IMPORTANT UPDATE INFORMATION

DOC NO. UM-694TX-L1

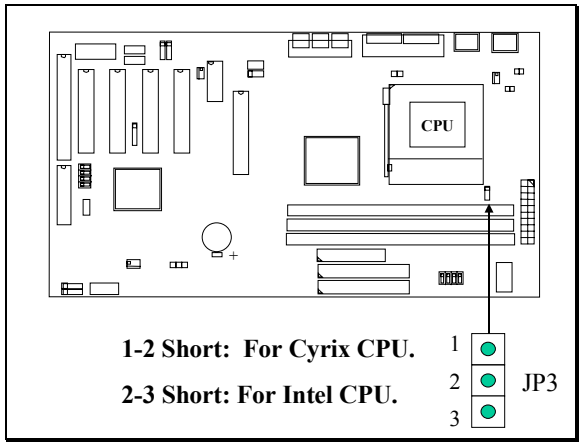
1. JP3 (Page 3-16)
   JP3 is disabled and it is not installed on the mainboard.

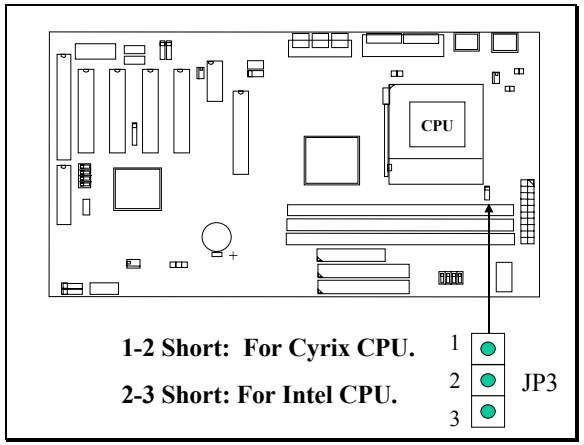
3. JP3 (Page 3-16)
   JP3 is disabled and it is not installed on the mainboard.
